### ADDENDUM No. 3

Date: August 15, 2025

Project: Roseburg Regional Airport  
Airport Fencing & Security Upgrades

C-601

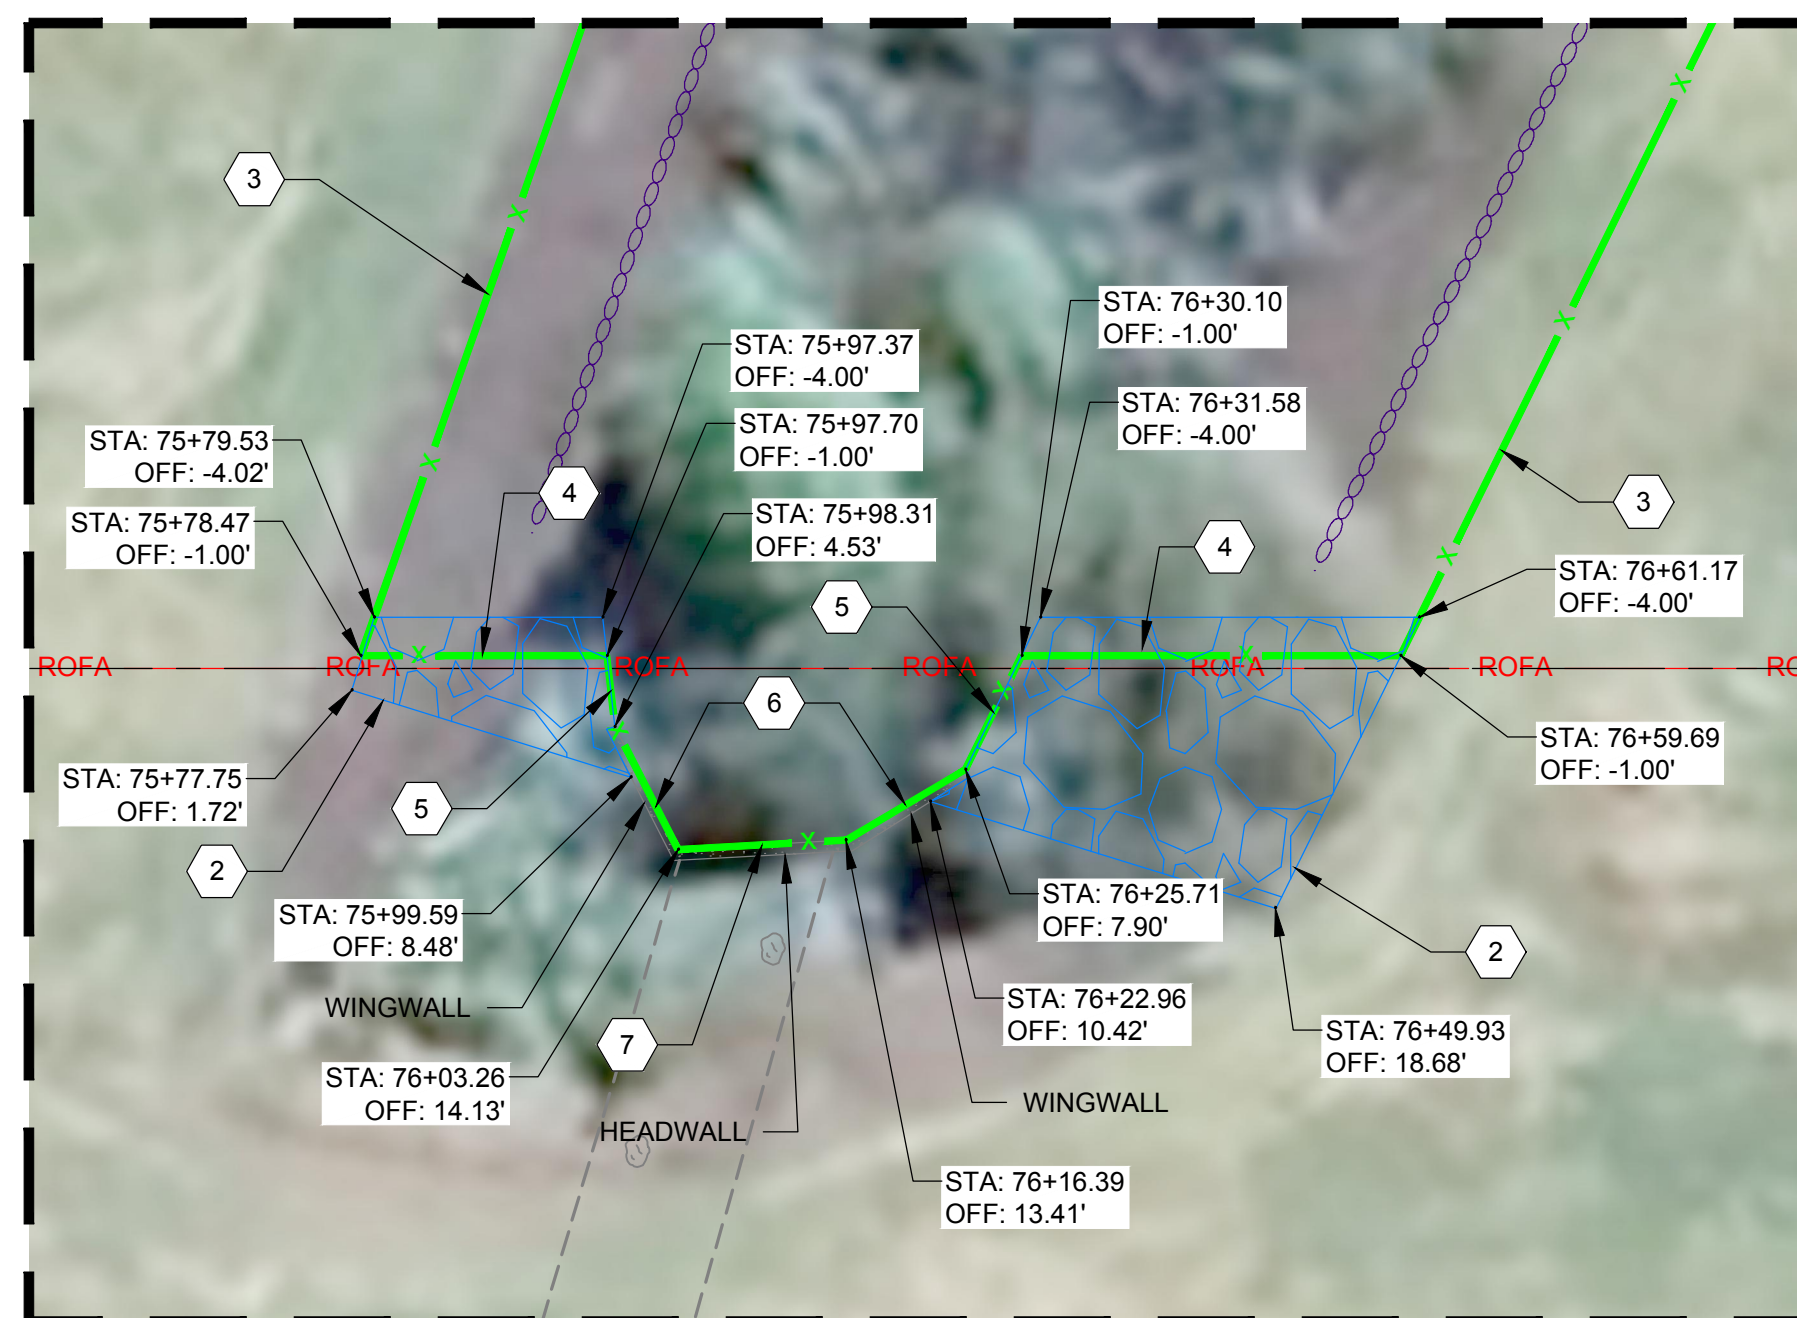
##### **C-601**

- Added Straw Wattles

## 2 STRAW WATTLE DETAIL

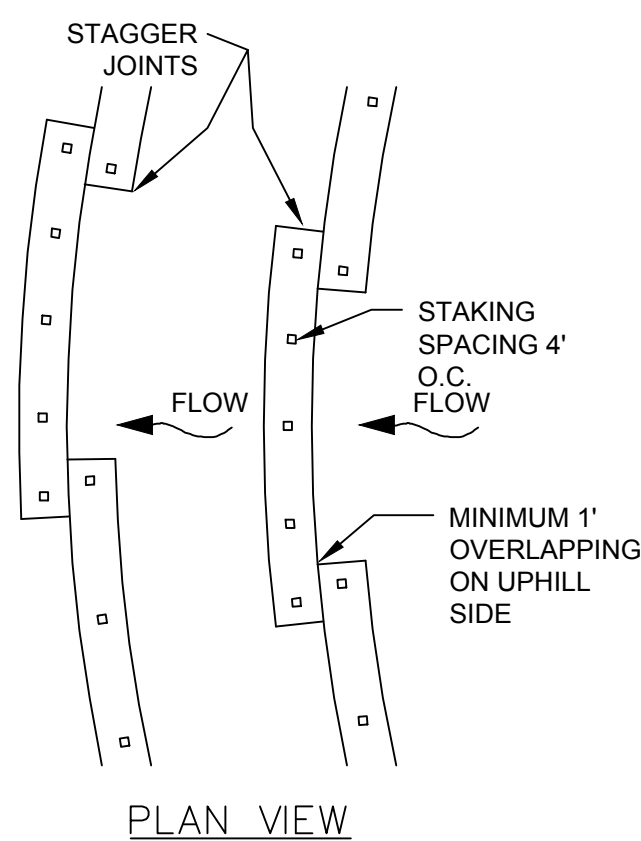
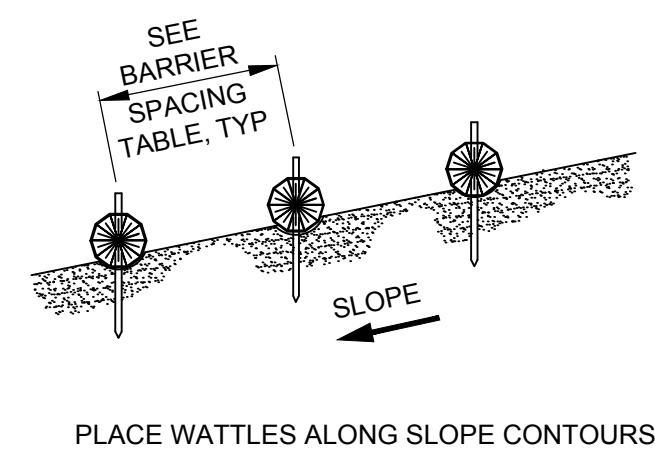
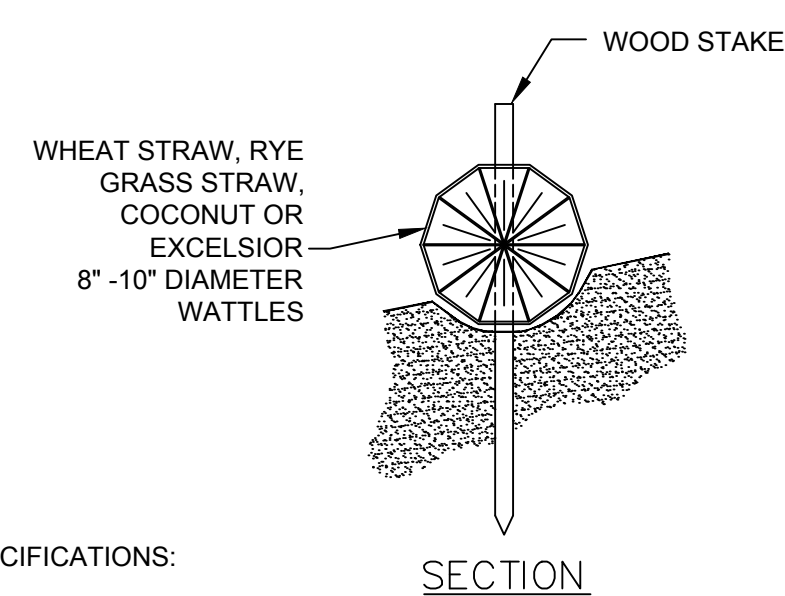
##### **P-101: Add Straw Wattles**

- ADD Section P-101 4.3:

“101-4.3 Erosion and pollution control work required for the initial and final erosion control along with maintenance of erosion control will be performed as directed by the RPR. Payment will be made at the contract unit price for completed and accepted work:

Measurement for straw wattles shall be made at the contract unit price per linear foot, which price and payment shall be full compensation for furnishing and installing all materials and for all labor, equipment, tools, and incidentals necessary to install, maintain and remove the work as shown or prescribed on the plans or in this item.”
